Multistrada 1200 Enduro Rear Shock Absorber

Models: Model Year 2016-2017 Multistrada 1200 Enduro (all country versions)

Recall Bulletin SRV-RCL-17-002

NHTSA Campaign I.D. Number: 17V274
Transport Canada Safety Recall I.D. Number: 2017-223

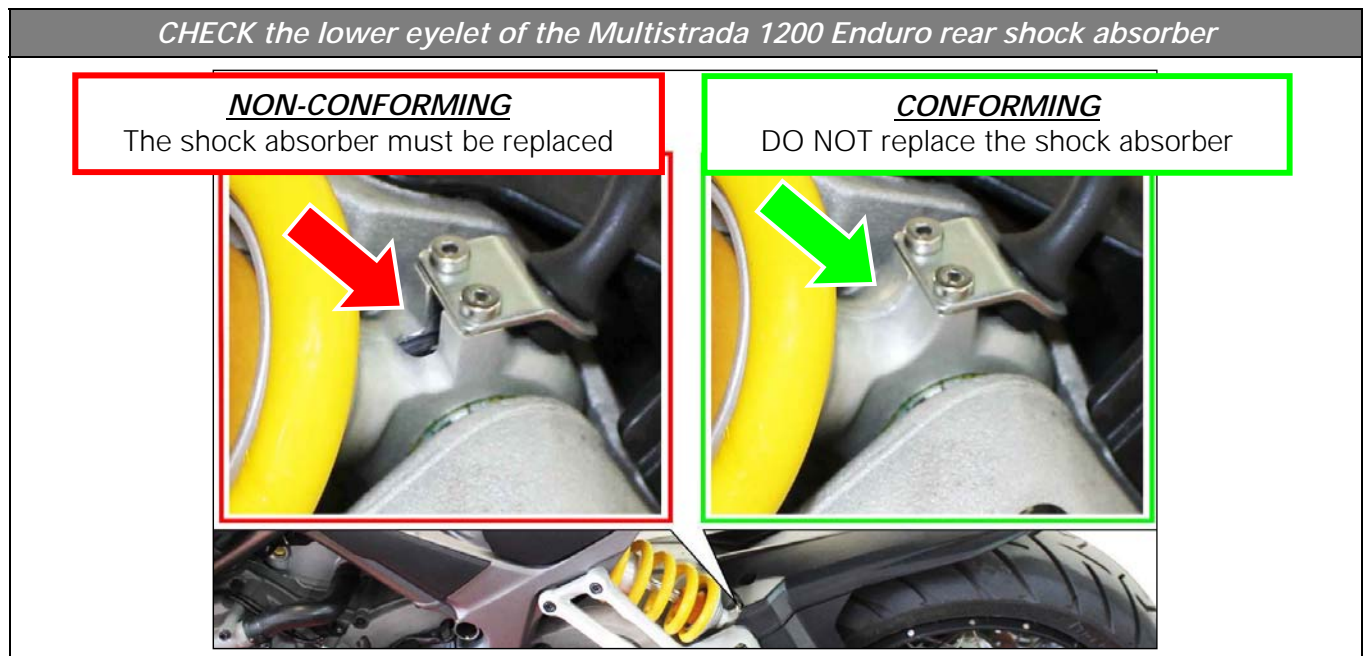
Continuous quality tests on the product in operation has revealed a potential problem with the lower eyelet of the Sachs semi-active rear shock absorber, which attaches the shock absorber to the swing-arm. Intense off-road use of the Multistrada 1200 Enduro could lead to breakage of the lower eyelet. To prevent possible breakage, the lower eyelet of the rear shock absorber was redesigned to make it more robust. The new part number of the rear shock absorber with modified eyelet is 36521464A.

On the motorcycles involved it is therefore necessary to perform a visual inspection of the eyelet structure; and if it is not conforming proceed with the replacement of the shock absorber.
